NASA Electronic Parts and Packaging (NEPP) Program 2019 Electronics Technology Workshop

NEPP Program Task 19-294 Government Working Group Update

June 2019

FIGURE 2012-7. Lid seal voids and rejection criterion.

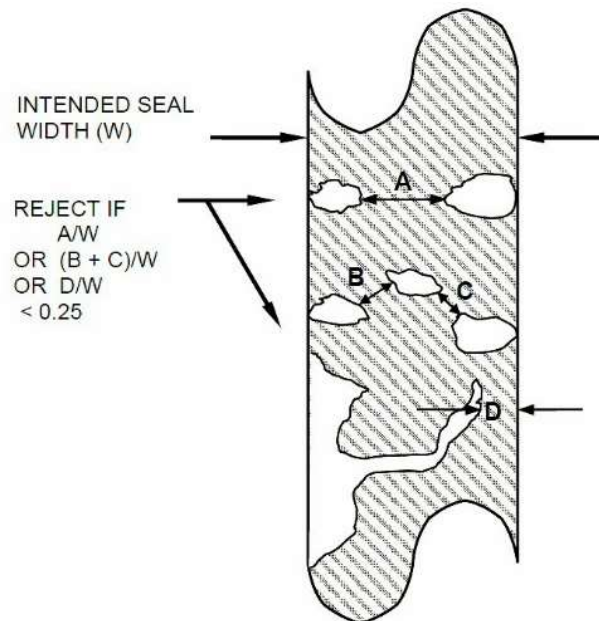
- **In the 2017/2018 timeframe, GWG developed a unified stance disapproving two JEDEC Task Group 15-02 X-Ray Seal Voids proposals to change MIL-STD-883 TM2012 lid seal void requirements.**
 - **Initial Proposal: Increase voiding criteria from 75% to 95%**
 - ❑ A GWG consensus objection letter signed by NASA, US Air Force (SMC/AFMC), Navy, and Army representatives was sent to DLA
 - **Second Proposal: Inclusion of fillet in the intended seal width**
 - ❑ Two GWG opposition presentations were given by Kathy Laird/NASA-JSEG and Matt Dorcon/NSWC Crane at the JEDEC JC13 Task Group 15-02 X-Ray Seal Voids Meeting in January 2018.

- Any device wherein the integral lid seal is not continuous or is reduced from its designed sealing width by more than 75 percent.
- Width reduction to less than 75% may be the result of either a single void or a combination of voids in the same width area (see figure 2012-7).

➤ Fillets are not included in the designed (intended) sealing width.

- After the GWG presentations, it was agreed by the JEDEC task group in January 2018 that the inclusion of the fillet as part of the intended seal width would not be added to MIL-STD-883 TM2012 due to the fact that:

- The formation of the fillet is not a design feature of the seal process. Fillets form when solder flows out from under the lid during the seal process.

- In most if not all cases, the fillet width by itself would meet the 25% required seal width.
- The GWG also recommended the fillet allowance stated in MIL-STD-750 TM2076 be removed. This allowance will be removed in the next draft.

FIGURE 2076-7. Design sealing width and seal fillet graphic.

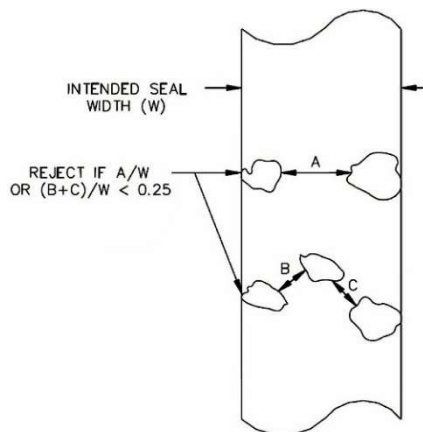
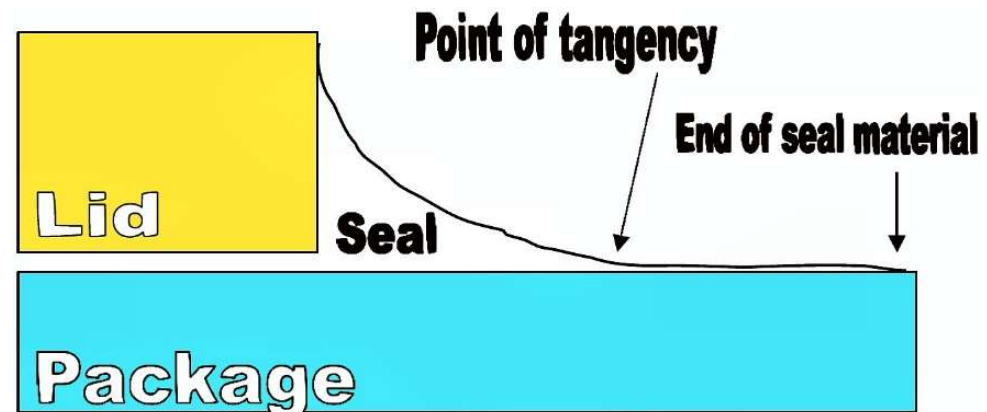
• MIL-STD-750 TM2076 Lid Seal Voids Requirements – Includes Fillet

- 1.1.1 Designed sealing width. The metalized area where the package lid overlaps the package base (see figure 2076–7).
- 1.1.2 Seal fillet. Exuded seal material, usually concave in shape, which extends from the edge of the package lid to the point of tangency of the package base (see figure 2076–7).
- 3.8.2.3.2 Defective seal (see figure 2076–2). Any device wherein the lid seal (including the seal fillet when present) is not continuous or is reduced from its designed sealing width by more than 75 percent. The designed sealing width may be reduced by multiple voids (not to include pin hole voids).

• Justification Not to Allow Inclusion of Fillet in Intended Lid Seal Width

- DLA Land and Maritime has no history of why fillet was included in the seal width for MIL-STD-750 product (requirement inserted in TM2076 in 1/3/2012)
 - M750 has significantly tighter leak rates than M883 and some believe the fillet inclusion was a compromise since tighter leak rates and this change were made in the same timeframe.
- The fillet is not a design feature of the seal process.
 - Fillet width is not a controlled process.
 - Fillet forms when solder flows out from under the lid during the sealing process, and tapering of the fillet results in a non-uniform seal width (see figures on Slide 8).
 - Solder pullback severity can negate the seal effectiveness of the fillet.
 - Microcrack(s) not distinguished in x-rays may compromise seal integrity as they can propagate to a void area when part is placed on board or during box level and system level testing.

- GWG asked DLA and JEDEC for technical justification of why the fillet was added in the 1/2012 release. They could not find any technical justification.

• Example 1: Excessive Voiding Underneath Lid

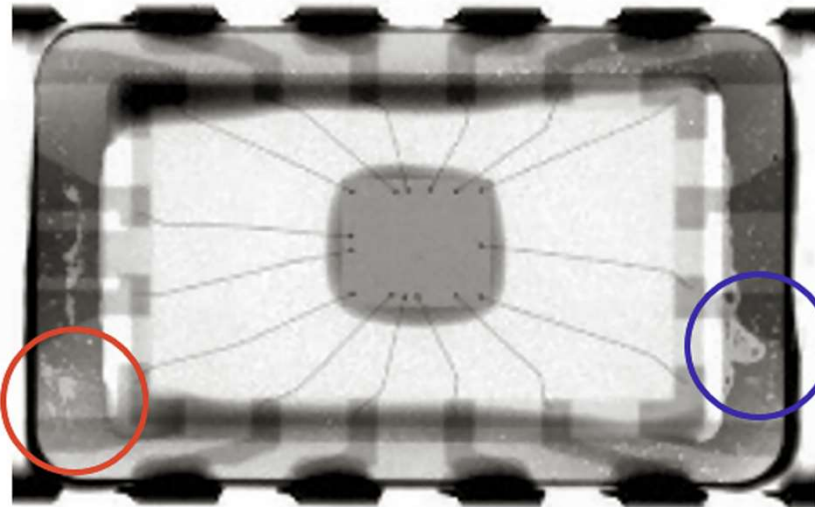
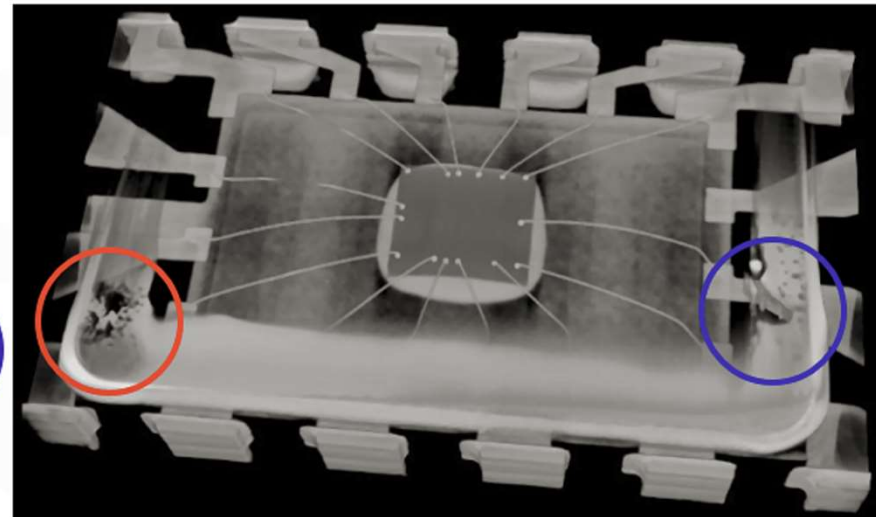
- Voids may reduce sealing width underneath the lid by more than 75% and also contact the fillet.
 - Microcrack(s), not distinguished in x-ray, may compromise seal integrity as they can propagate to a void area.
- The current lid seal requirements would fail this device, yet pass if the fillet is included in the intended seal width.

This part was a randomly selected sample and had this void issue. Because this part was randomly selected, it is highly probable that there are other parts with similar issues.

• Example 1: Excessive Voiding Underneath Lid (continued)

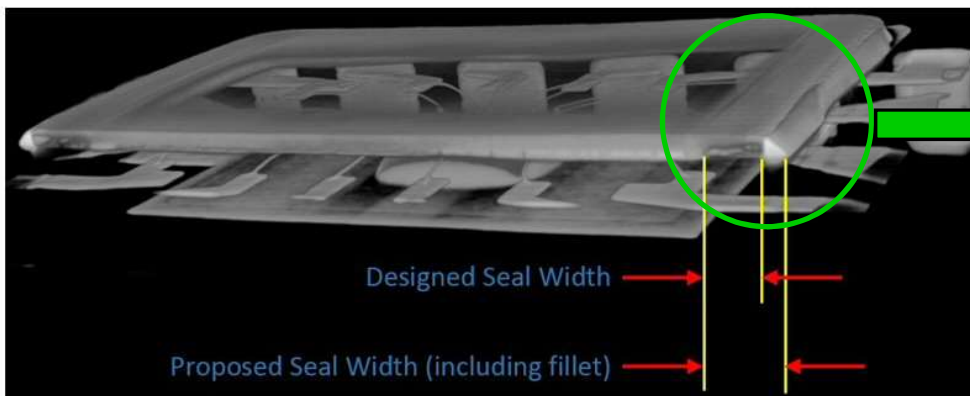
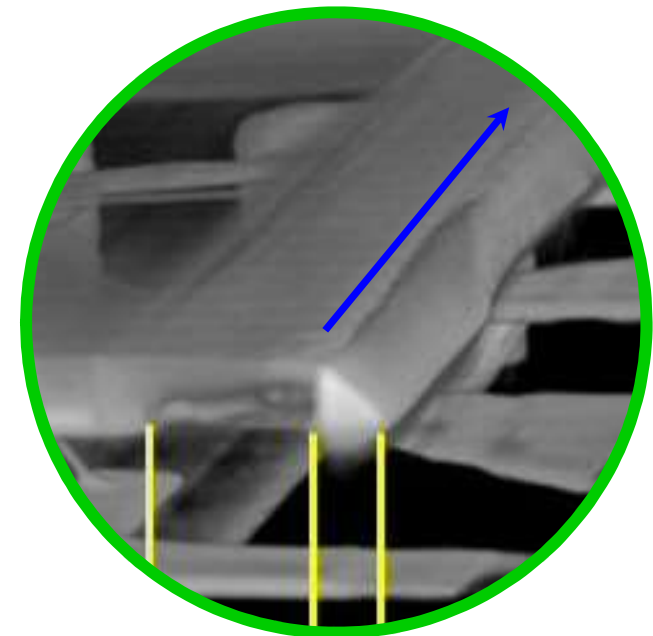
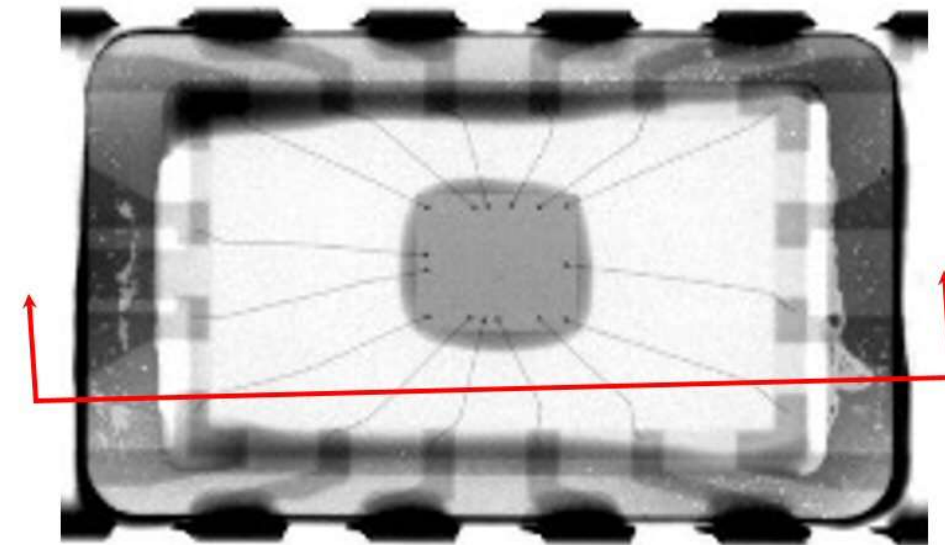
- The current lid seal requirements would fail this device, yet it would pass if the fillet is included in the intended seal width.

Darkened areas in the designed seal width are voids and the fillet width tapers (blue arrow).

• Example 2: Excessive Voiding Underneath Lid

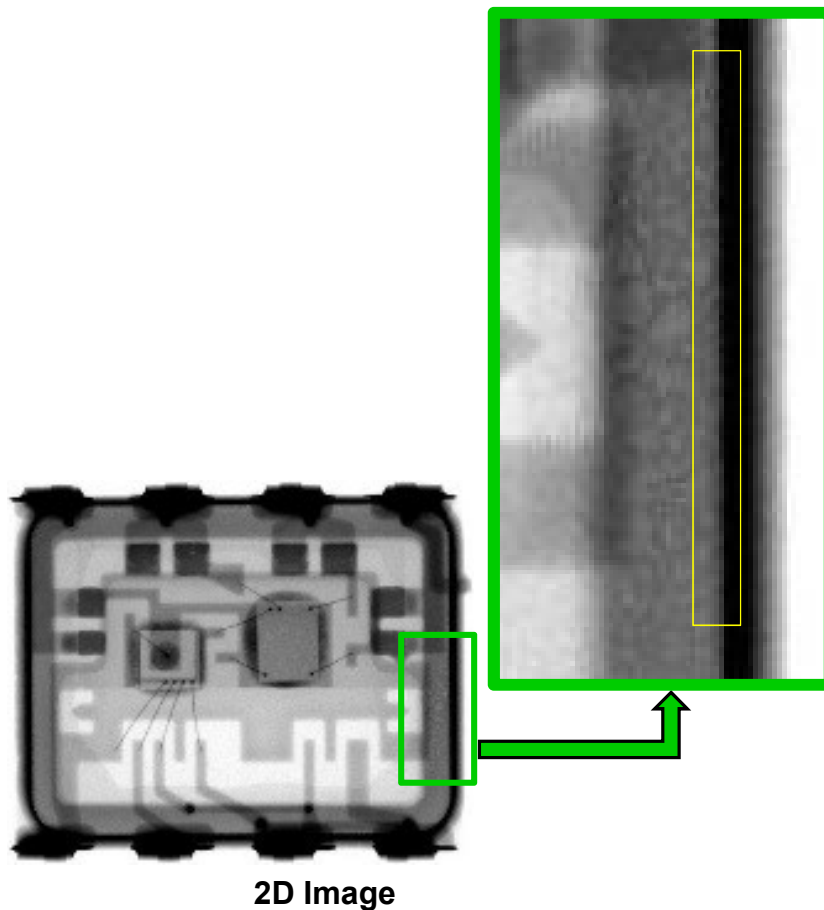
- Voids reduce sealing width underneath the lid by more than 75% and pinholes exist in fillet area next to the lid. Note that the pinholes are not clearly detected in the 2D x-ray image (yellow box) due to the thick, x-ray dense solder of the fillet.

• Example 2: Excessive Voiding Underneath Lid (continued)

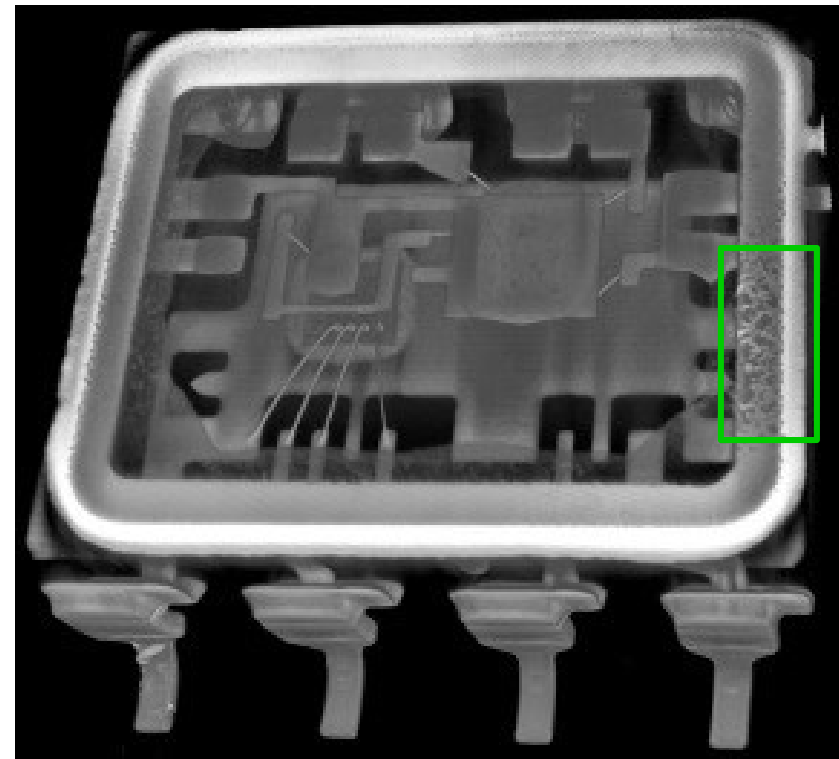
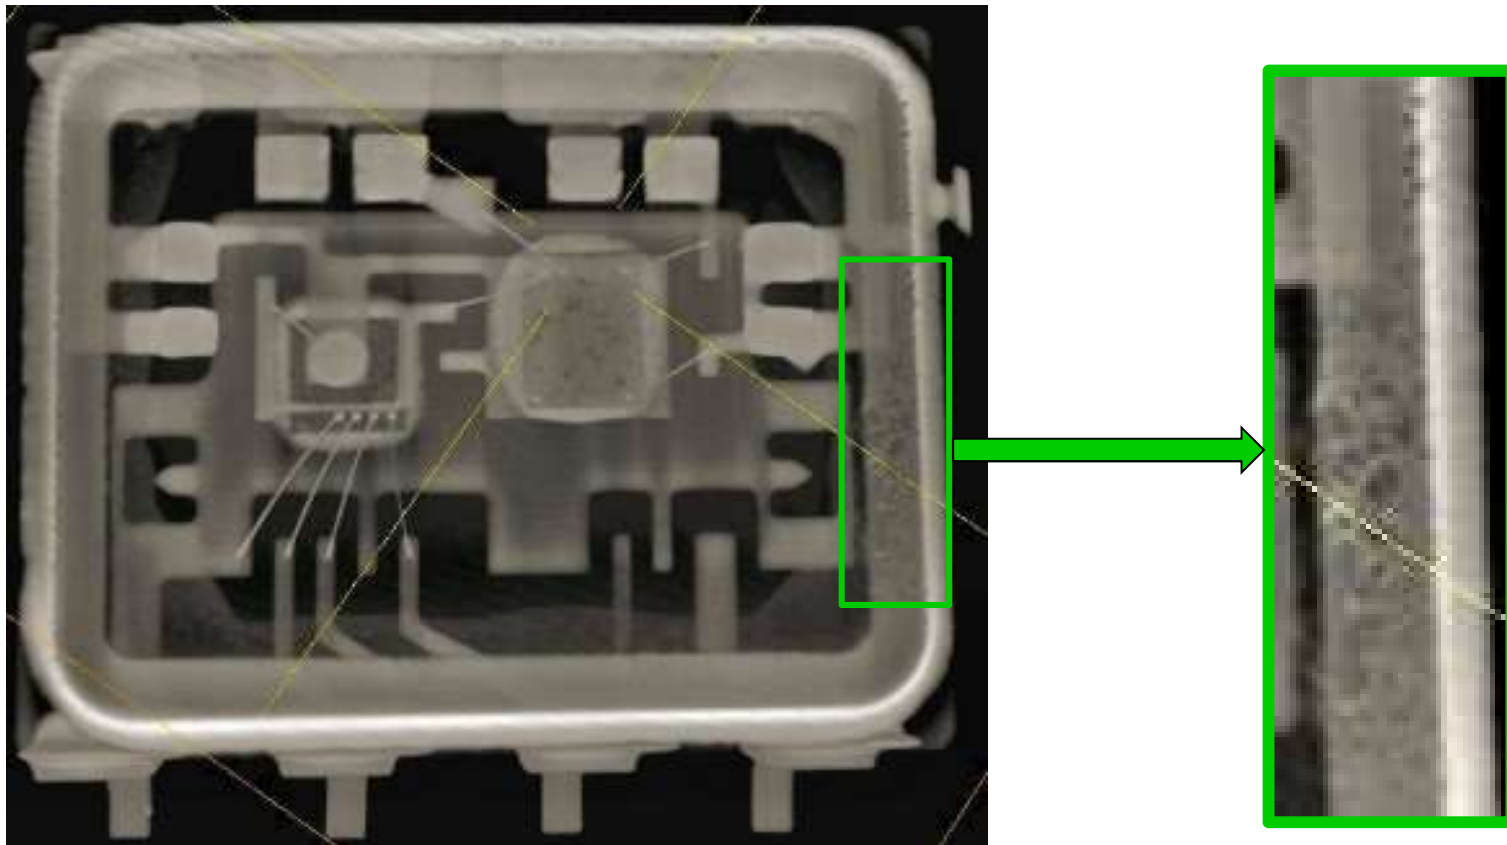
- Another 3D-CT image of the device shown on Slide 9. This part would fail the current criteria, but would pass if the fillet was included in the design width. Note the pinholes in the fillet next to the edge of the lid, which provides a potential leak path.

FIGURE 2012-5. Lid seal voids and rejection criterion.

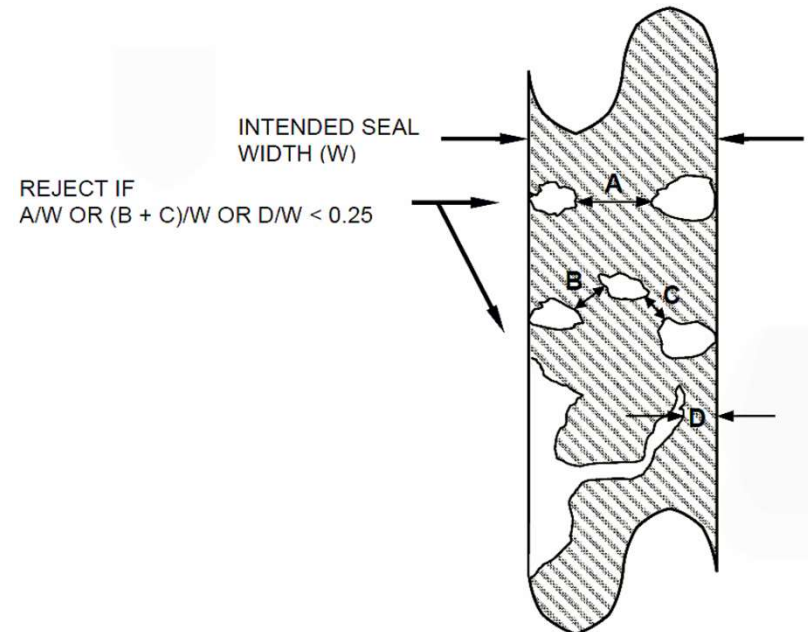
- **JEDEC Task Group proposal to change MIL-STD-883 TM2012 X-ray lid seal failure criterion.**

- Would remove “B + C” requirement and replace with seal length calculation along perpendicular line drawn from edge of package to cavity
- Would allow fillets to be part of intended seal width
- GWG does not support this change

X-ray Image of Voids

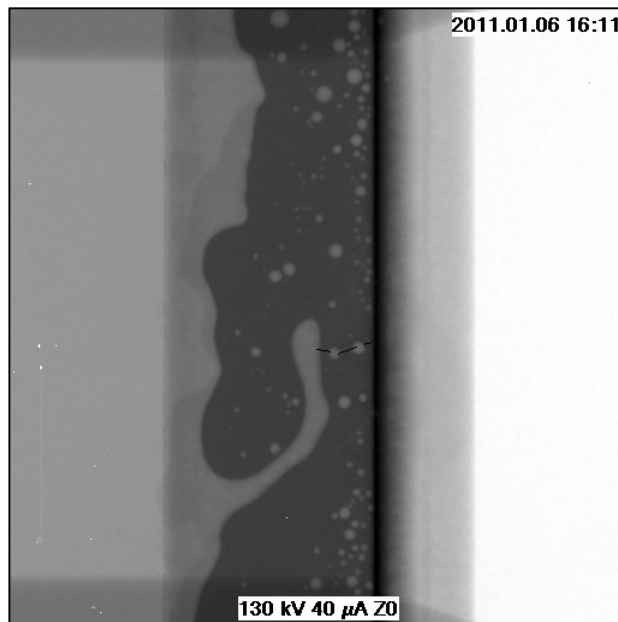
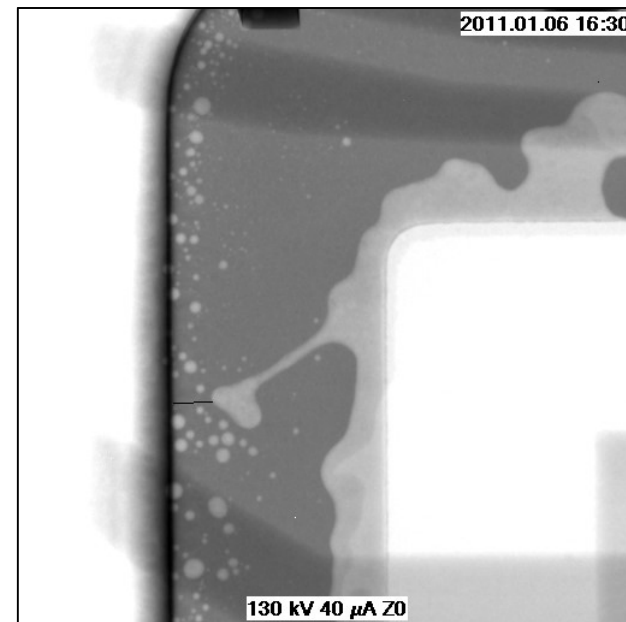
- JEDEC Task Group proposal to change MIL-STD-883 TM2012 X-ray lid seal failure criterion (cont.)
 - These microcircuits would pass the proposed criteria
